DEVELOPMENT FACILITATION TEAM (DFT) APPLICATIONS

OFFICIAL NOTIFICATION OF DECISION

John R. Metz 366 Los Ranchos NW Albuquerque, NM 87107 **Project # PR-2022-007999** SI-2023-01621- Site Plan- EPC

CONDITIONS OF APPROVAL - SI-2023-01621

RE: Storage Building 336 Woodward Rd. SE Conceptual Grading & Drainage Plan Engineer's Stamp Date: 01/06/23 Hydrology File: M14D037

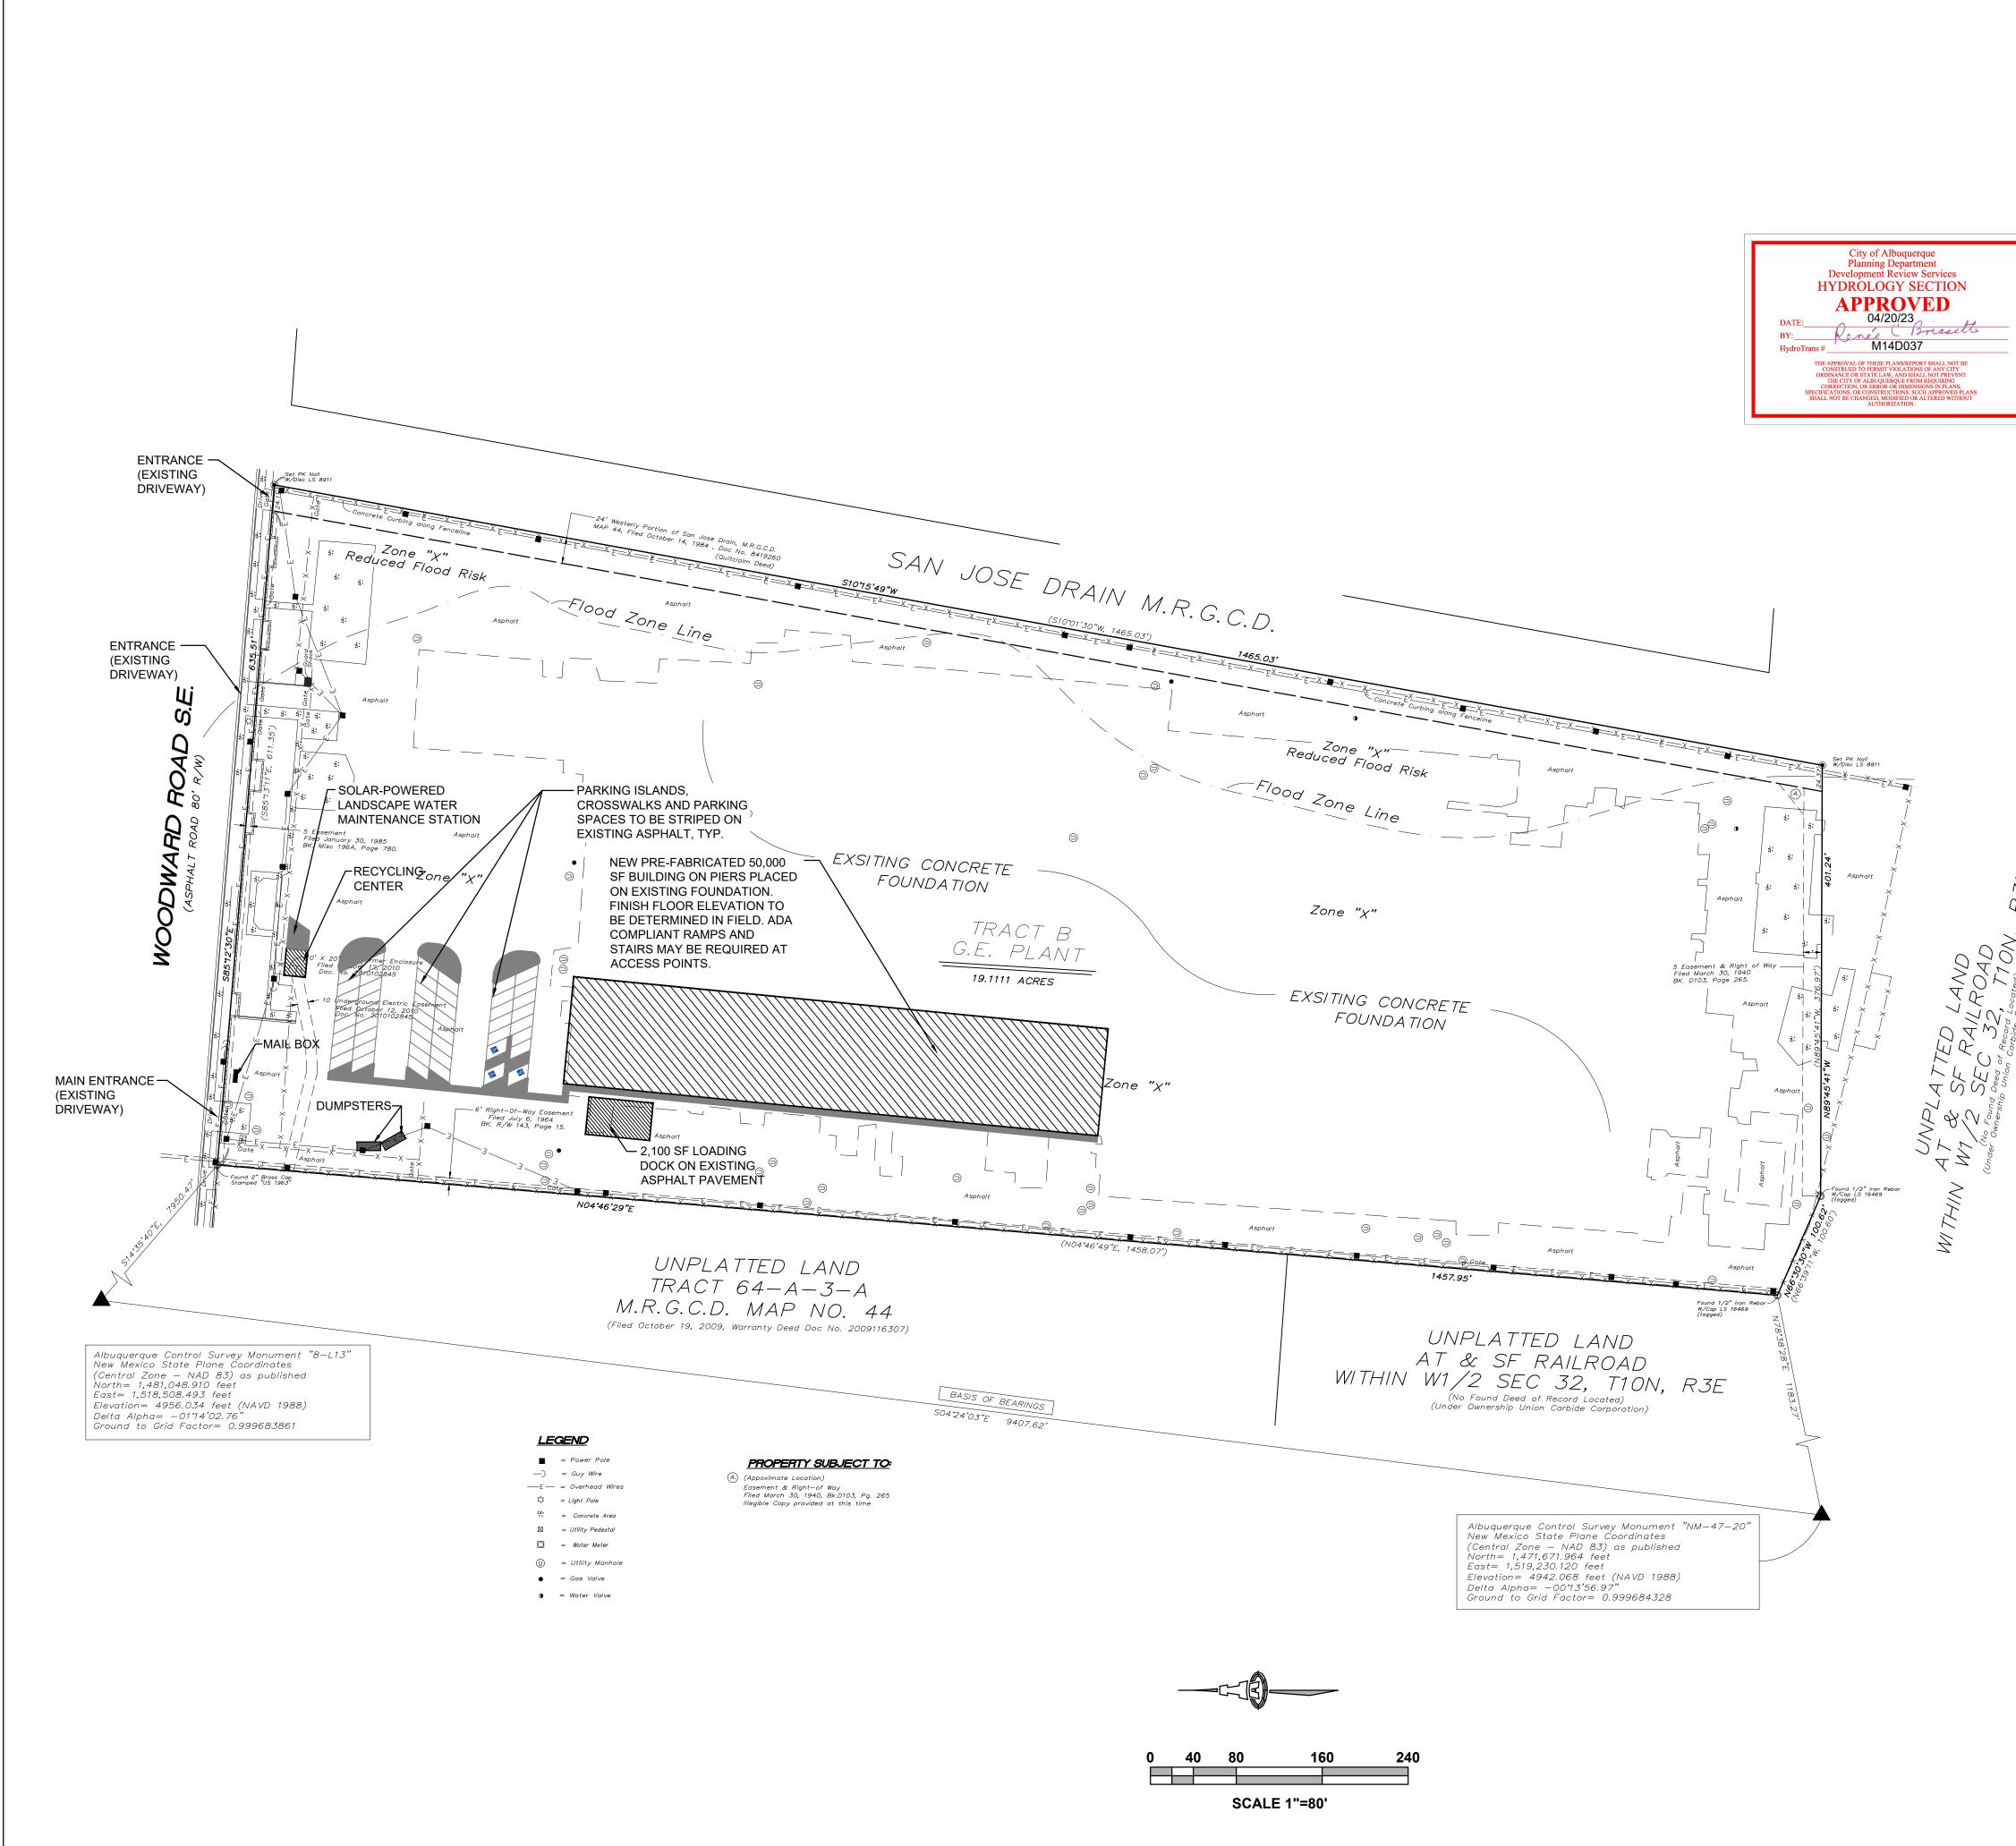
PO Box 1293 Based upon the information provided in your submittal received 04/13/2023, the Grading & Drainage Plan is approved for Building Permit. Please attach a copy of this approved plan in the construction sets for Building Permit processing along with a copy of this letter.

1. Engineer's Certification, per the DPM Part 6-14 (F): Engineer's Certification Checklist For
Non-Subdivision is required.
